Safety cover for bend drive unit XSEW-XHEW

Safety device

Safety cover

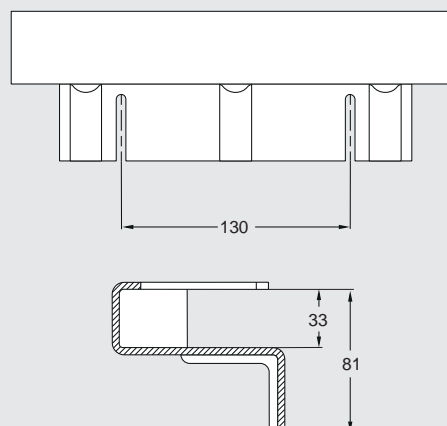
All horizontal bend drive units are now delivered with a cover designed to act as a personnel safety device.

The safety cover can also be ordered separately to be mounted on to older drive units. The cover is then delivered in one standard size, but since the distance between the conveyor beams differ between XS, XL, XM and XH drive units, the cover will need to be cut at both ends to fit properly.

When mounting the cover on to older drive units, two attachment holes (M5) need to be drilled in the drive unit bracket.

Two MC6S 5x12 screws are required for attachment of the safety cover.
